**Subject: Response to Comments on First Quarter 2021 GMZ Monitoring and System Performance Report
Hamilton Sundstrand Corporation (HSC) Plant 1/2 Facility
Southeast Rockford Groundwater Contamination Superfund Site, Rockford, Illinois (ILD981000417)**

On behalf of Hamilton Sundstrand Corporation (HSC), AECOM Technical Services Inc. (AECOM) has completed this response letter to the United States Environmental Protection Agency (USEPA) June 29, 2021 comment letter regarding the First Quarter 2021 GMZ Monitoring and System Performance Report for the HSC Plant 1/2 Facility in Rockford, Illinois (Site).

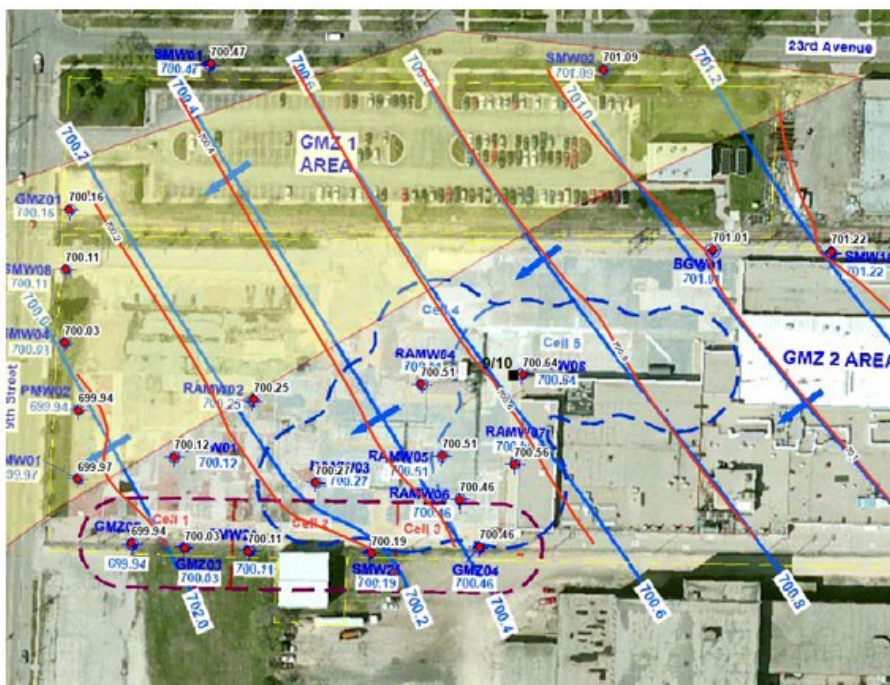
It appears from the well sampling data along the southern border of the GMZ 2 Area that the air sparge/soil vapor extraction (AS/SVE) system has removed a significant portion of the contaminants from the Phase 1 and Phase 2 areas of influence. However, the AS/SVE system was not intended to affect the area shaded in yellow (see figure below) which potentially contains unknown source areas or known source areas that have not been sufficiently mitigated and would be still leaching VOCs to the groundwater system. This seems to be the case as depicted in Figure 4 and Figure 5 of this report (western GMZ Area 1 and 2 boundary wells).

One such potential source is the OSA where there are known tetrachloroethene (PCE) concentrations at depth that exceed the preliminary remediation goal (PRG) for soil (60 ug/kg, soil component for protection of groundwater) within the 26 to 30 foot below ground surface (bgs) interval, where groundwater levels are present and have been recorded, and the OSA is upgradient of GMZ01 and SMW08. There are also same order of magnitude concentrations of PCE (40-60 ug/kg), although less than the PRG, as deep as 32 feet bgs in the OSA.

It will also be telling if the AS/SVE system is impacting PMW01 along the western boundary. The upcoming quarterly event results during system shutdown would provide information for further evaluation of this concept.

Response: Comment noted.
